APPLICATION NO.	FILING DATE	FIRST NAMED INVENTOR	ATTORNEY DOCKET NO.	CONFIRMATION NO
09/972,448	10/06/2001	Koya Suzuki	5000-4960 4076	
7590 11/05/2003			EXAMINER	
MORGAN & FINNEGAN, L.L.P. 345 Park Avenue			GARCIA, ERNESTO	
New York, NY 10154			ART UNIT	PAPER NUMBER
			3679	
			DATE MAILED: 11/05/2003

`.	Application No.	A cant(s)				
	09/972,448	SUZUKI ET AL.				
Office Action Summary	Examin r	Art Unit				
	Ernesto Garcia	3679				
The MAILING DATE of this communication appears on the cover sheet with the correspondence address Period for Reply						
A SHORTENED STATUTORY PERIOD FOR REPLY IS SET TO EXPIRE 3 MONTH(S) FROM THE MAILING DATE OF THIS COMMUNICATION. - Extensions of time may be available under the provisions of 37 CFR 1.136(a). In no event, however, may a reply be timely filed after SIX (6) MONTHS from the mailing date of this communication. - If the period for reply specified above is less than thirty (30) days, a reply within the statutory minimum of thirty (30) days will be considered timely. - If NO period for reply is specified above, the maximum statutory period will apply and will expire SIX (6) MONTHS from the mailing date of this communication. - Failure to reply

【図8】

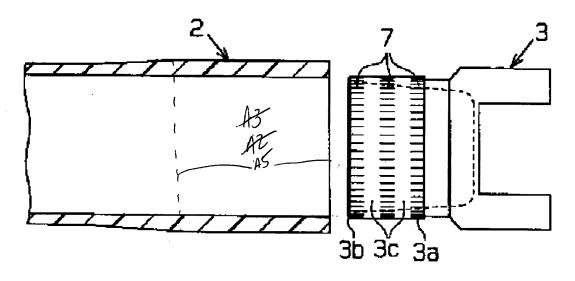
Regarding claim 1, Yasuchika et al. disclose in Figures 7 and 8 a first member 3, and second member 2. The first member 3 has a serration portion 7b provided at a pressure insertion end portion A3 of the first member 3. The second member 2 has a pressure insertion portion A5. The first member 3 has a surface contact portion A6 at location adjacent to the serration portion 7b. The surface contact portion A6 includes a step portion A7 provided between a leading end portion A8 of the pressure insertion end portion A3 and the serration portion 7b. A diameter A9 of the step portion A7 is set between a diameter A10 of the pressure insertion portion A5 and a diameter A11 of the serration portion 7b. The first member 3 is a metal yoke of a propeller shaft and the second member 2 is a fiberglass reinforced plastic cylinder of the propeller shaft (see English abstract).

Regarding claim 3, the serration portion **7b** is provided to an outer circumferential surface of the pressure insertion end portion **A3**.

Regarding claim 6, after the second member 2 is joined to the serration portion **7b**, the step portion **A7** is in non-contact with the second member **2**.

Regarding claim 7, the first member 3 has a chamfering portion 3b extended from the leading end portion A8 to the step portion A7.

Regarding claim 15, the step portion **A7** is formed cylindrically between the leading end portion **A8** and the serration portion **7b**.
